Access Compliance Report Public Rights-of-Way (Curb Ramps)

Intersection ID: 49701 Main Street: SCOTTSMAN TRACE DR **Cross Street: HIGHLAND MEADOW RD** Location: SE ADA ID: AE98C808A2BA Ramp Type: PerpDiag Initial Pass/Fail: Fail **Overall Compliance: No Severity Score:** 37.5

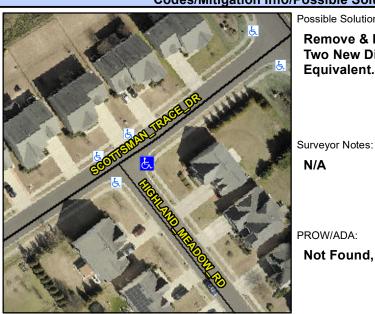
Not Found, R304.2.2, R304.5.3

Compliance Description		Data	Compliance		Description	Data
N/A	Ramp Length (in)	48.0	No	Ramp	Slope (%)	8.8
Yes	Ramp Width (in)	48.0	No	Ramp	XSlope (%)	9.2
N/A	Flare Type LT	N/A	N/A	Flare	Type RT	N/A
N/A	Flare Slope LT (%)	N/A	N/A	Flare	Slope RT (%)	N/A
N/A	Flare Traversable LT?	N/A	N/A	Flare	Traversable RT?	N/A
N/A	Landing Length (in)	N/A	N/A	DWS	Provided?	N/A
N/A	Landing Width (in)	N/A	N/A	DWS	Contrast?	N/A
N/A	Landing Slope (%)	N/A	N/A	DWS	Length (in)	N/A
N/A	Landing X Slope (%)	N/A	N/A	DWS	Full Width?	N/A
N/A	Landing Curb? (Y/N)	N/A	N/A	DWS	Offset (in)	N/A
N/A	Shared Landing?	N/A				
N/A	Gutter Ponding?	N/A	N/A	Gutte	r Slope (%)	N/A
N/A	Gutter Lip Ht (in)	N/A	N/A	Gutte	r X Slope (%)	N/A
N/A	Painted X Walk1?	No	N/A	Paint	ed X Walk2?	No
	X Walk 1 Direction	To NW		X Wa	lk 2 Direction	To SW
N/A	X Walk 1 Width (in)	N/A	N/A	X Wa	lk 2 Width (in)	N/A
	X Walk 1 Slope (%)	8.4		X Wa	lk 2 Slope (%)	0.5
	X Walk 1 X Slope (%)	2.2		X Wa	lk 2 X Slope (%)	4.2

SCOTTSMAN TRACE DR None **HIGHLAND MEADOW RD** StopSign Possible Solutions: Remove & Replace Curb Ramp With **Two New Directional Ramps or** Equivalent.
